Video Products Technical Bulletin 30-2005-058

SUBJECT: REUSE IC101 WHEN REPLACING THE A BOARD

MODEL: PVM-14M2U

Figure 1

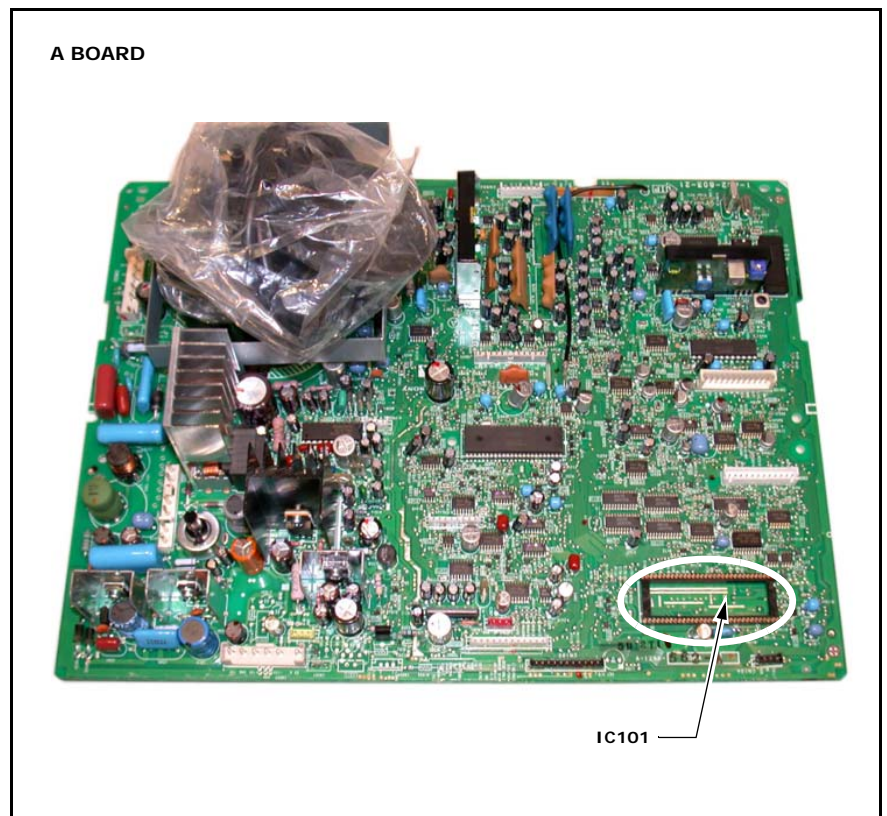
When you replace the A board (A-1298-562-A), remove IC101 (IC UPD78014FYCW-W42, 6-802-004-01) from the former board and install it on the new board.

The new A board does not contain IC101, and IC101 is no longer available as a service part. (See Figure 1.)
